**ADDENDUM 01**  
**RAMONA-ALESSANDRO ELEMENTARY SCHOOL**  
**FENCING UPGRADES**

**DSA APP# 04-125095**

San Bernardino City Unified School District  
San Bernardino, California

May 1, 2026

**FENCE POST EXTENSION**  
SCALE: 1/2" = 1'-0"

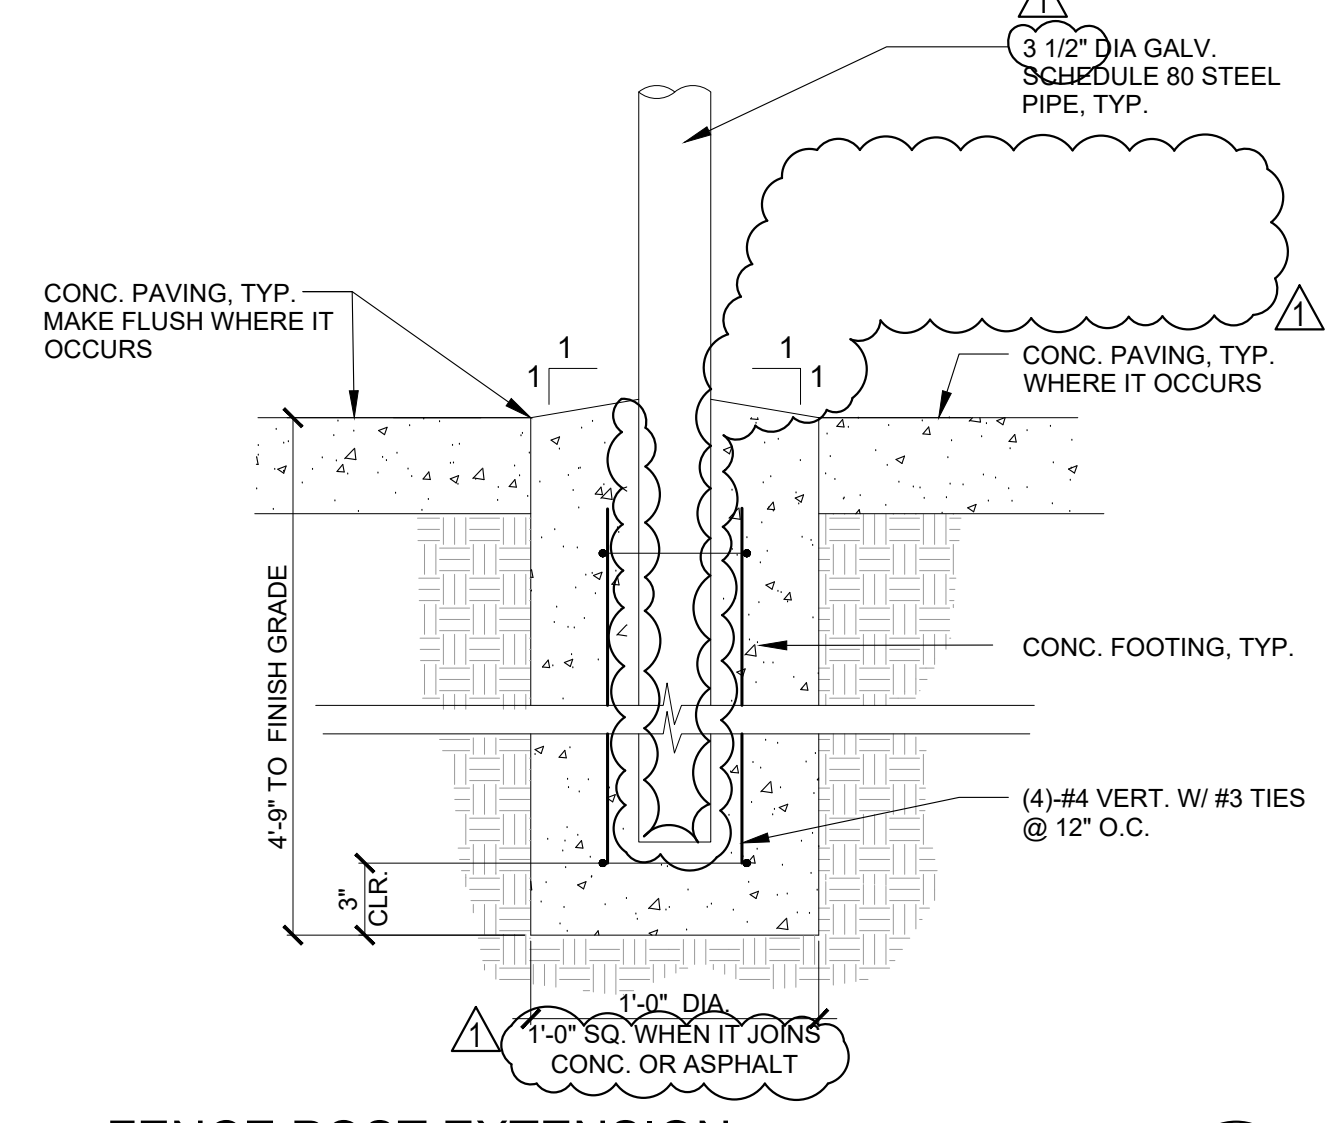
- On Ram-Ale, Detail 8/A003 calls for "Flexible Sealant all around typ." This is not typical at all. Please provide a sealant or remove from scope as it is very unusual.
- Also detail 8/A003 calls for "non-shrink grout all around typ" this is not typical. Can we use concrete? Please remove verbage from scope.
- Detail 8/A003 has the footing as 12" w x 4'9" deep however specs call for 18" w x 4'6" deep. Please clarify which one is correct.
- Detail 8/A003 calls the post as 3" Dim galv Sch 80 painted black. However the specs call for 3.5" x sch 40. Please clarify. [32 3] 13-2]

1. Refer to Addendum 01 A003 revised detail 8.
2. Refer to Addendum 01 A003 revised detail 8.
3. Refer to Addendum 01 revised Chain Link Fences and Gates Specification Section 32 31 13.
4. Refer to Addendum 01 A003 revised detail 8 and revised Chain Link Fences and Gates Specification Section 32 31 13.

**TYP., ELEVATION CHAIN LINK FENCE & GATE**  
SCALE: 1/2" = 1'-0"

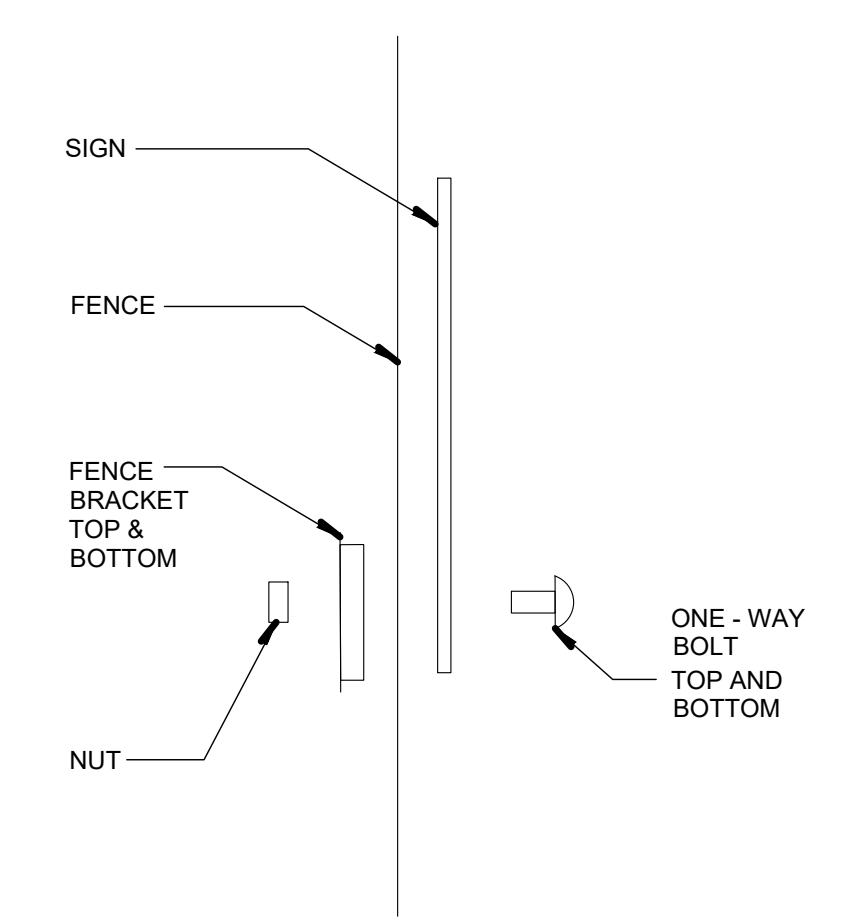
- 1/A003 & 4/A003 call for 2" mesh. While 3/A003 and specs call out 1". Please clarify.
- [32 31 13-3 [2.2.5]] "Slat Infill..." Confirm this can be removed from scope as there are no slatted fence in this project.
- [32 31 13-3 [2.2.4]] "Finish: Class 1 black zinc coating". Does not relate to fence fabric please provide an actual fence spec. As this is incorrect. I recommend Class 26 fused-bonded chain link.

- 6. Refer to Addendum 01 A003 revised details 1 and 4.
- 7. Refer to Addendum 01 revised Chain Link Fences and Gates Specification Section 32 31 13.
- 8. Refer to Addendum 01 revised Chain Link Fences and Gates Specification Section 32 31 13.
